# Work Order ID 96543

Item Name: Bearpaw

# DART SERVICE INSTRUCTION

TO AMEND INSTALLATION INSTRUCTIONS IIN-D135-692 REV. A AND  
INSTRUCTIONS FOR CONTINUED AIRWORTHINESS ICA-D135-692 REV. 0  
REF. FAA STC: SR01042SE

D3049-1 BEARPAW

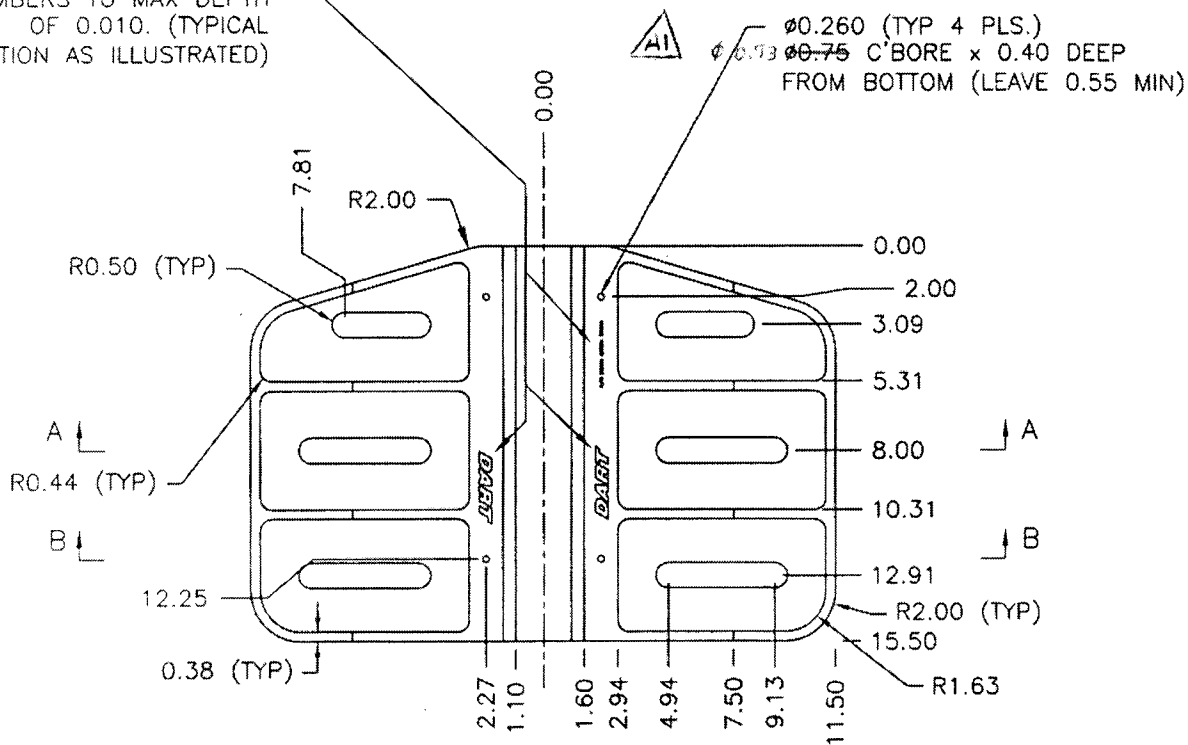
DESIGN RF	DRAWN BY RF	DART AEROSPACE LTD HAWKESBURY, ONTARIO, CANADA	
CHECKED [Signature]	APPROVED [Signature]	DRAWING NO. D3049	REV. A SHEET 1 OF 2
DATE 01.10.18		TITLE BEARPAW	SCALE 1:1
A	01.10.18	NEW ISSUE	
AI	03.01.13	[Signature] 0.93 WAS 0.75

**Figure 2 - Bearpaw Installation (IIN-D135-692)  
Figure 32-2: Bearpaw Installation (ICA-D135-692)**

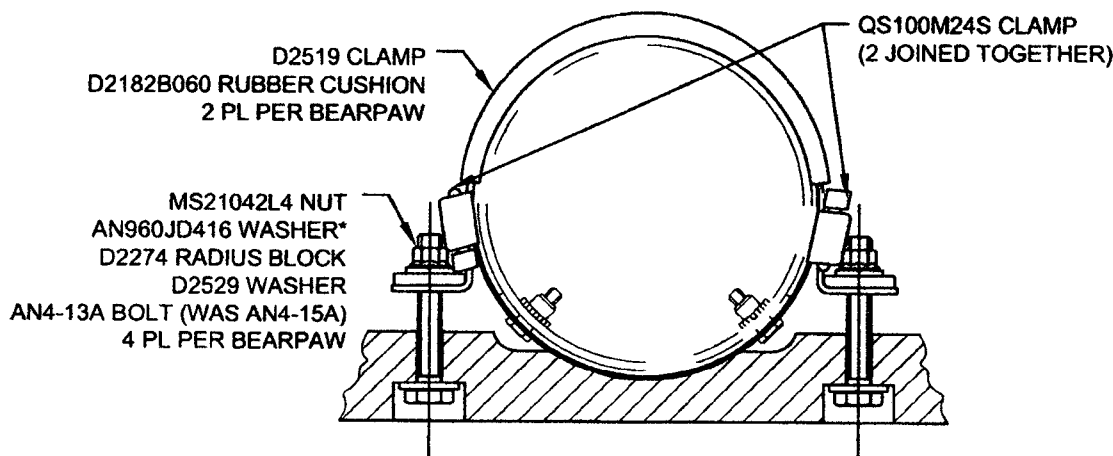
The purpose of this service instruction is to replace the AN4-15A Bolt with a shorter AN4-13A Bolt to facilitate installation.

Figure 2 of IIN-D135-692 and Figure 32-2 of ICA-D135-692 are amended as follows:

**IS:**

8	AN4-13A	BOLT
---	---------	------

**WAS:**

8	AN4-15A	BOLT
---	---------	------
